**TOWN OF HERNDON, VIRGINIA
ARCHITECTURAL REVIEW BOARD
PUBLIC HEARING AGENDA
MARCH 20, 2019
HERNDON COUNCIL CHAMBERS BUILDING
765 LYNN STREET
7:30 P.M.**

10. **APPLICATION FOR ALTERATION TO AN EXISTING STRUCTURE, ARB #19-03**, to consider an application to attach a new canopy with new address numbering attached to the canopy structure over the existing front entrance to the office building located at 12801 Worldgate Drive, Herndon, Virginia, and further identified as Fairfax County Tax Map 0164-02-0024A. Owner: Worldgate Dulles, LLC. Applicant: William H. Wilmer, Moore & Associates, Agent. ***Public hearing rescheduled from February 20, 2019, due to inclement weather.***

1 NORTH ELEVATION - NEW

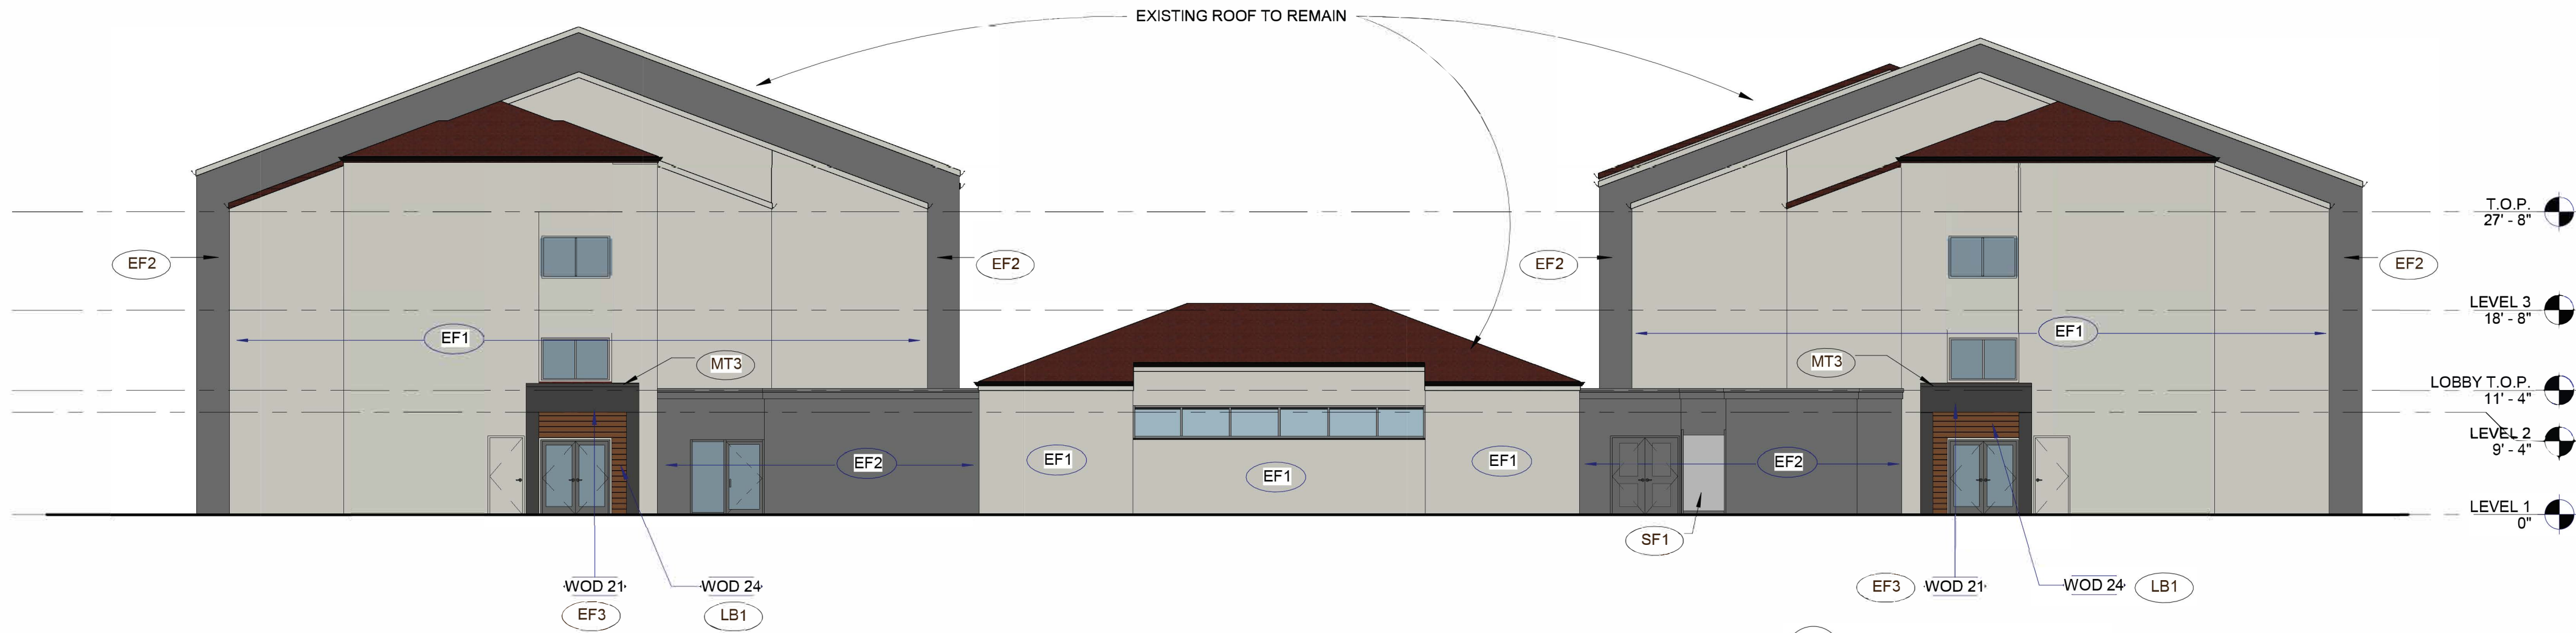
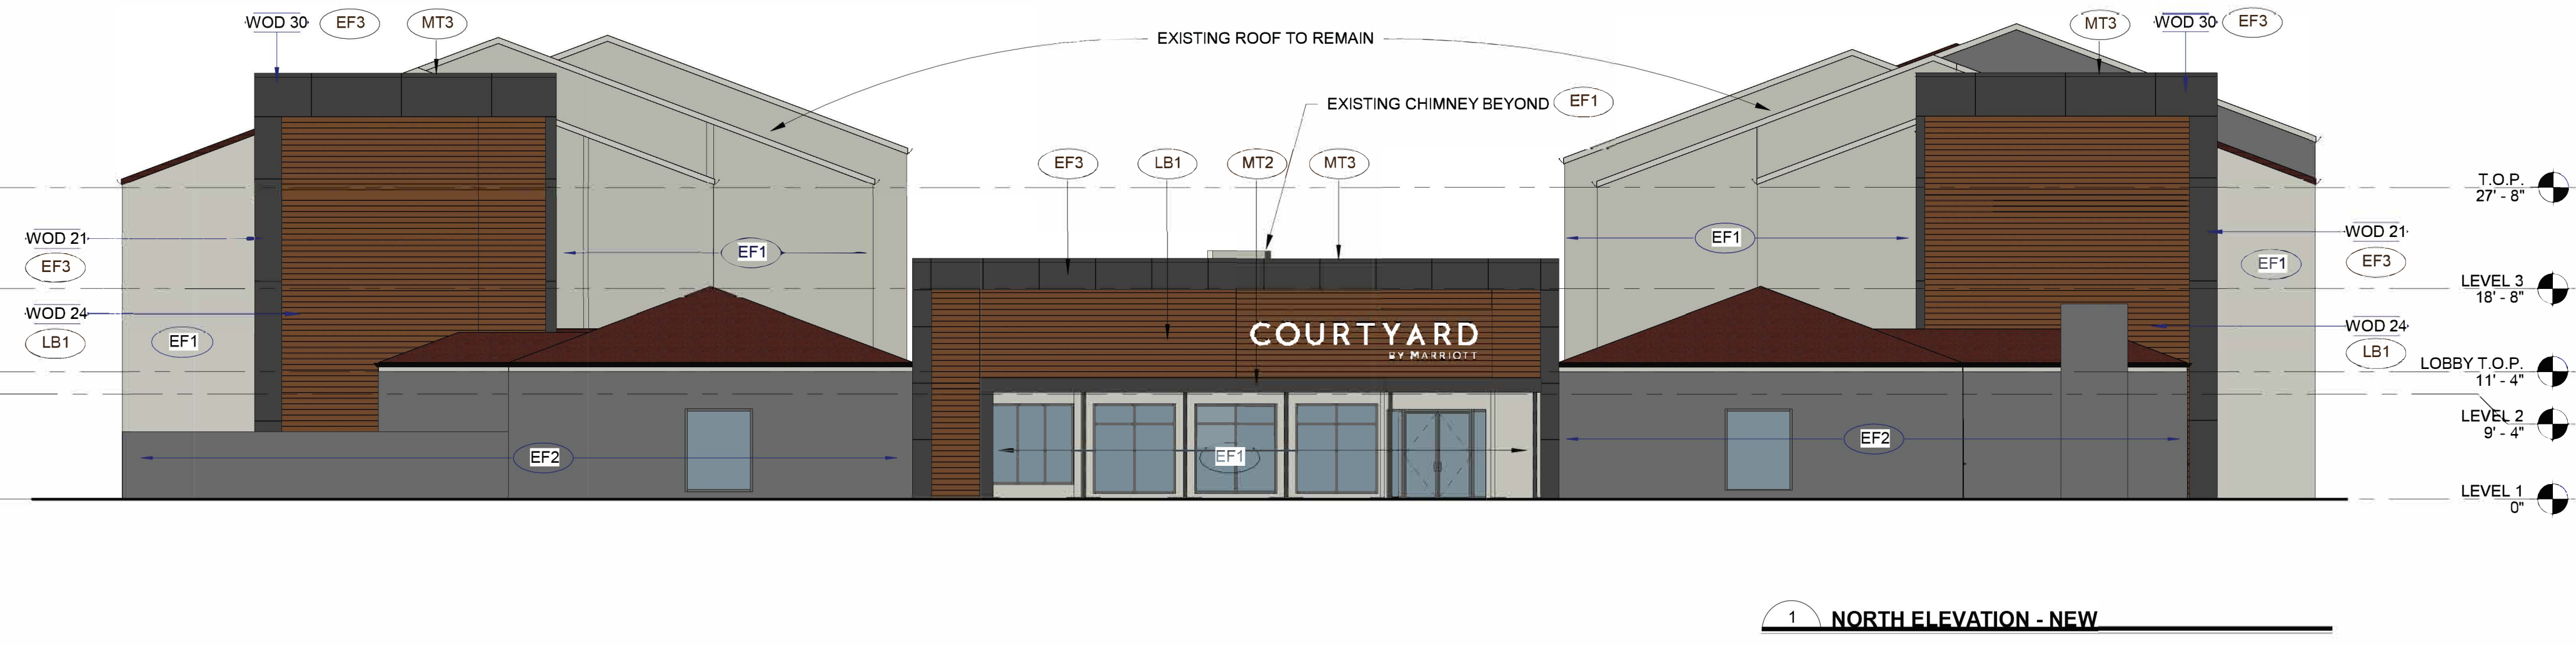
3. The architectural rendering of the north elevation on Sheet P200 of the Submission (Attachment #5) shows what appears to be some sort of mechanical feature on the roof. Staff will require clarification of this drawing feature. Should the object in the drawing be a mechanical system component, this feature will be subject to the Town's Zoning Ordinance Section Sec. 78-114 – Screening.

Response: The projection seen on Sheet P200 rendering is the back side of the existing chimney, on the courtyard side of the lobby. This can be seen on 1/P201 North Courtyard Elevation -New. This feature is now called out on 1/P200 North Elevation – New. It will be painted EF1 as indicated on 1/P201.
